# Access Compliance Report

## Public Rights-of-Way

### (Curb Ramps)

Intersection ID: 22532	Main Street: HARRISON_RD	Cross Street: HARRISONWOODS_PL	Location: SW
ADA ID: 27A18A8C5705	Ramp Type: PerpDiag	Initial Pass/Fail: Fail	Overall Compliance: No
Severity Score: 25			
Codes/Mitigation Info/Possible Solution		Field Measurements/Component Compliance

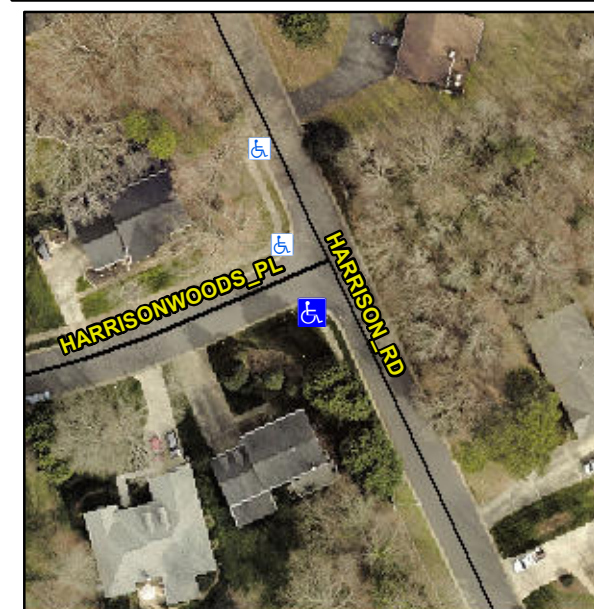
**Not Found, R304.5.3**

Compliance	Description	Data	Compliance	Description	Data
N/A	Ramp Length (in)	97.0	Yes	Ramp Slope (%)	6.2
Yes	Ramp Width (in)	76.0	No	Ramp XSlope (%)	7.5
N/A	Flare Type LT	N/A	N/A	Flare Type RT	N/A
N/A	Flare Slope LT (%)	N/A	N/A	Flare Slope RT (%)	N/A
N/A	Flare Traversable LT?	N/A	N/A	Flare Traversable RT?	N/A
N/A	Landing Length (in)	N/A	N/A	DWS Provided?	N/A
N/A	Landing Width (in)	N/A	N/A	DWS Contrast?	N/A
N/A	Landing Slope (%)	N/A	N/A	DWS Length (in)	N/A
N/A	Landing X Slope (%)	N/A	N/A	DWS Full Width?	N/A
N/A	Landing Curb? (Y/N)	N/A	N/A	DWS Offset (in)	N/A
N/A	Shared Landing?	N/A			
N/A	Gutter Ponding?	N/A	N/A	Gutter Slope (%)	N/A
N/A	Gutter Lip Ht (in)	N/A	N/A	Gutter X Slope (%)	N/A
N/A	Painted X Walk1?	No	N/A	Painted X Walk2?	No
	X Walk 1 Direction	To NE		X Walk 2 Direction	To NW
N/A	X Walk 1 Width (in)	N/A	N/A	X Walk 2 Width (in)	N/A
	X Walk 1 Slope (%)	10.8		X Walk 2 Slope (%)	3.5
	X Walk 1 X Slope (%)	0.2		X Walk 2 X Slope (%)	5.9

**Remove & Replace Curb Ramp With Two New Directional Ramps or Equivalent.**
